TRAILS AT ASPEN RIDGE - FILING NO. 5

8" PUBLIC SANITARY MAIN PLANS

TITLE SHEET

DRAWING No.
TS01

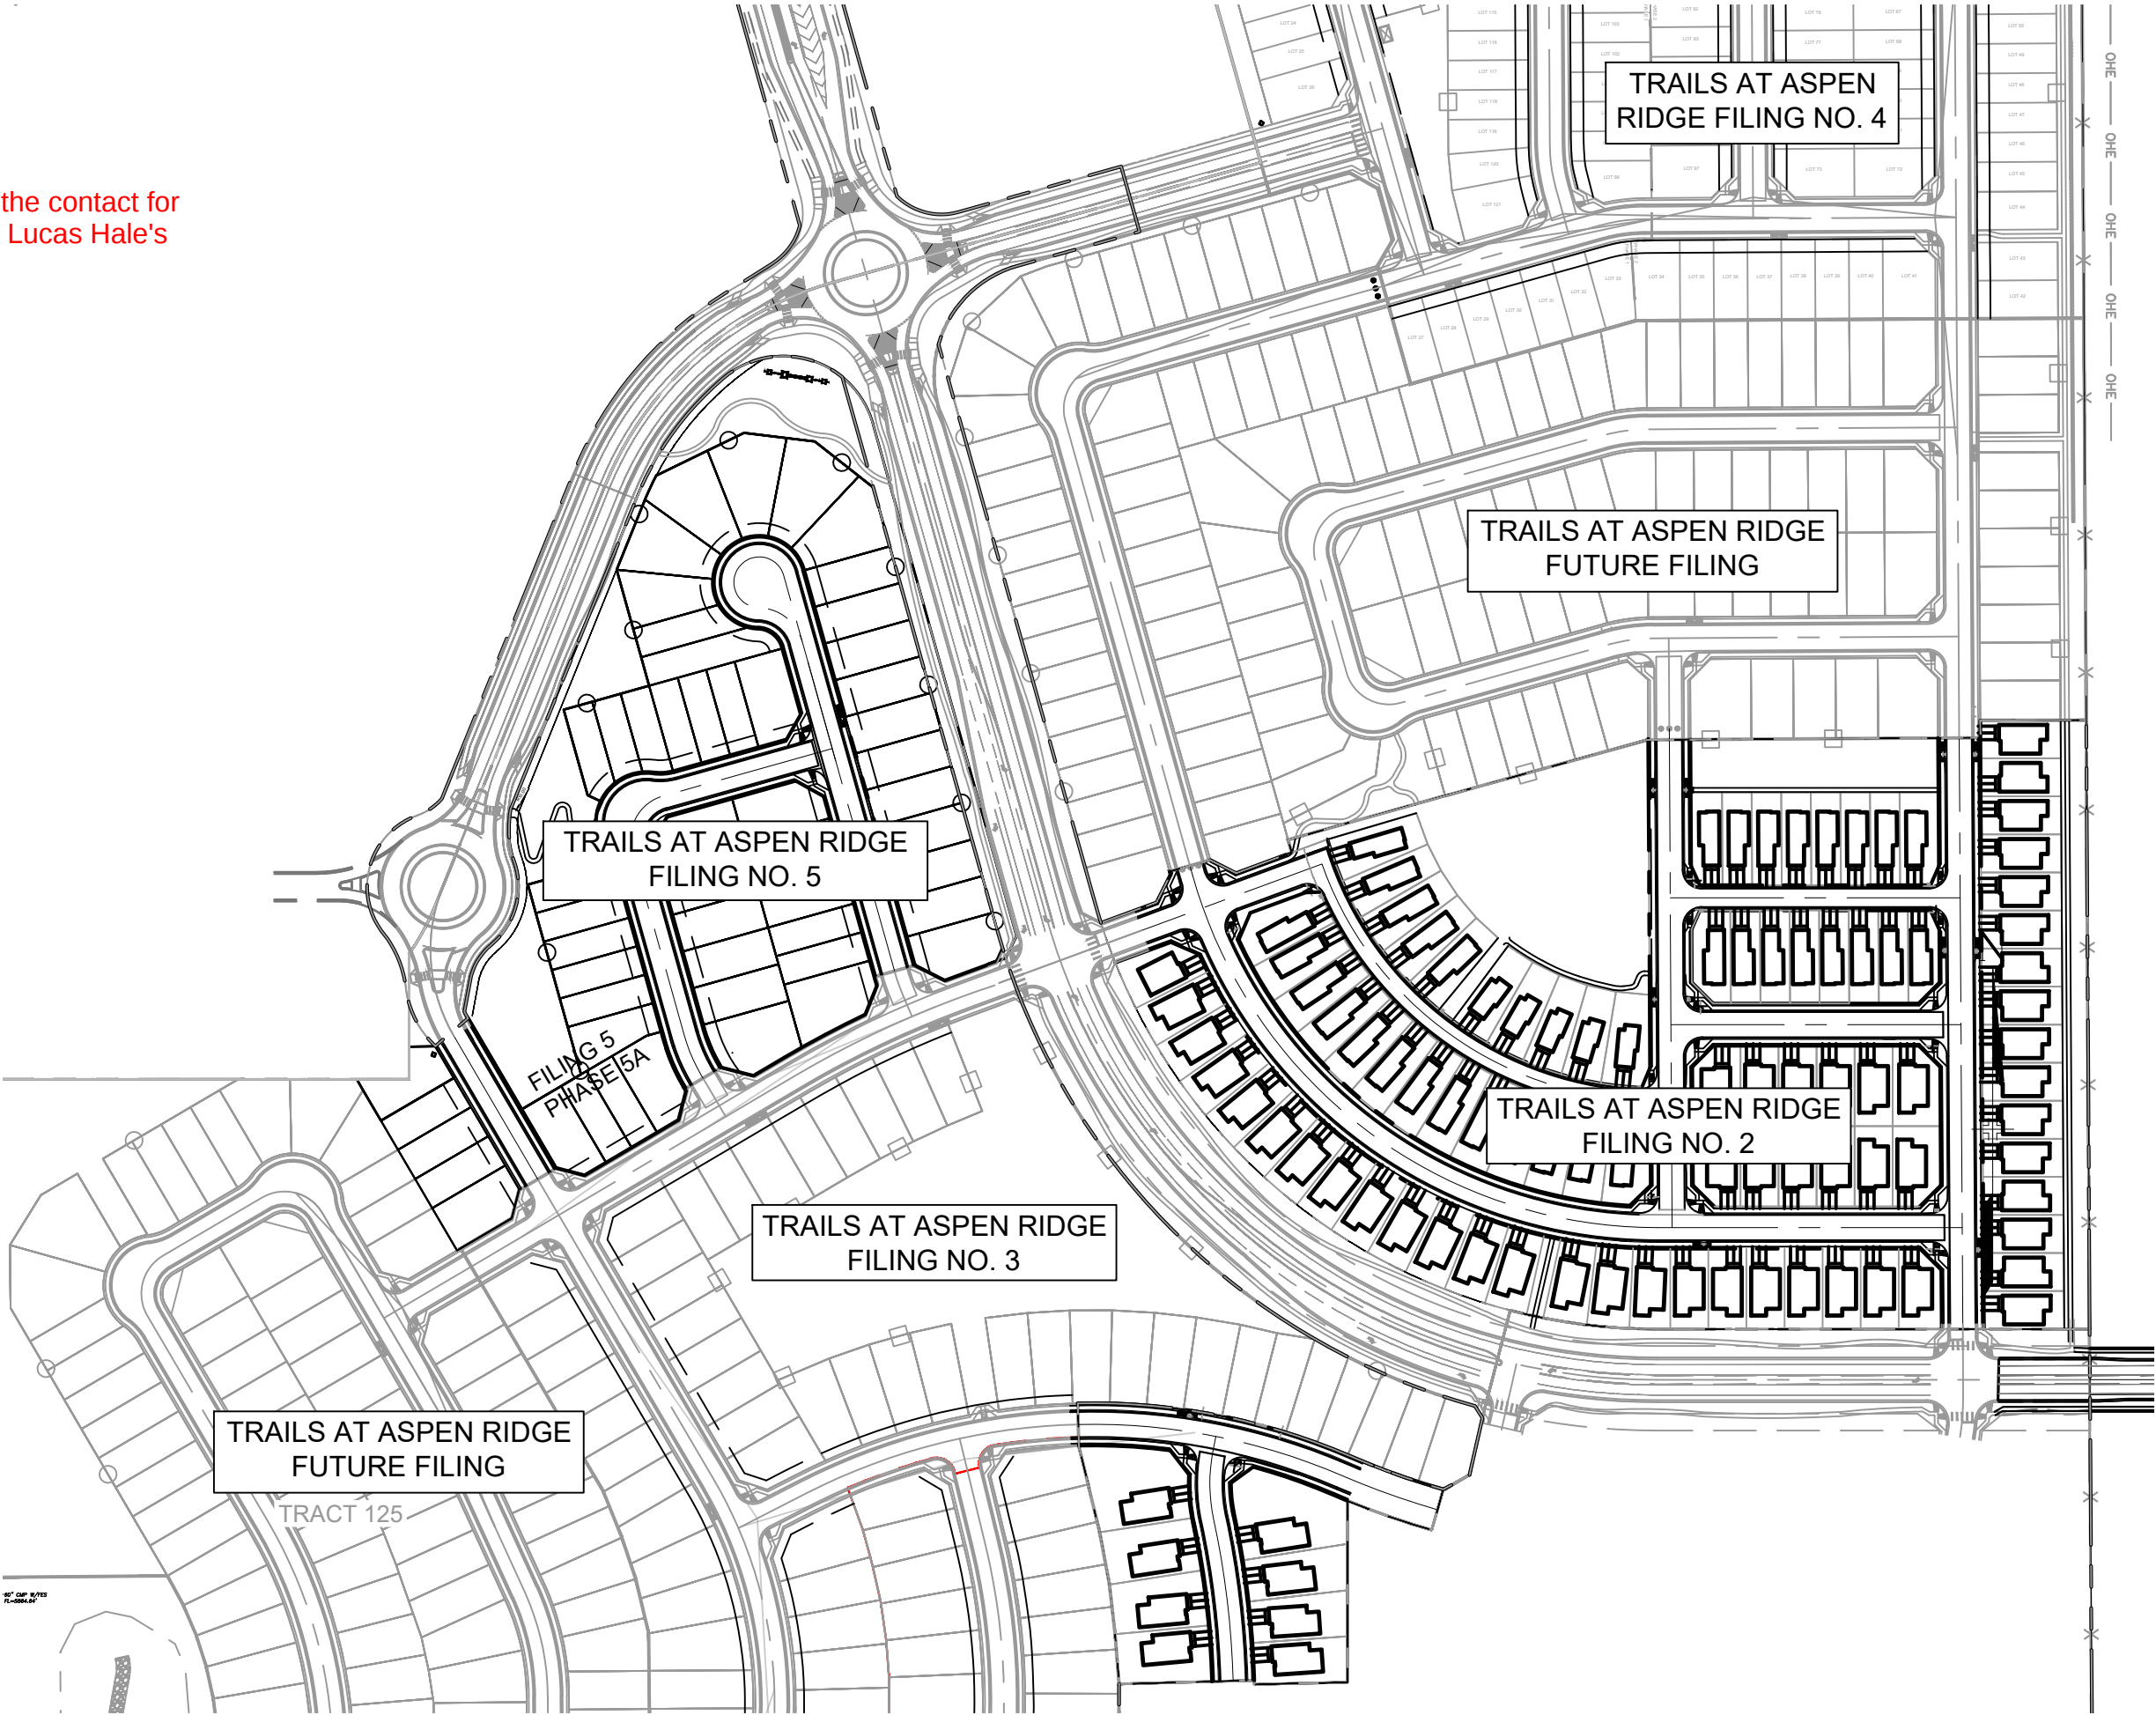
Robert is no longer the contact for WWSD, please use Lucas Hale's contact info.
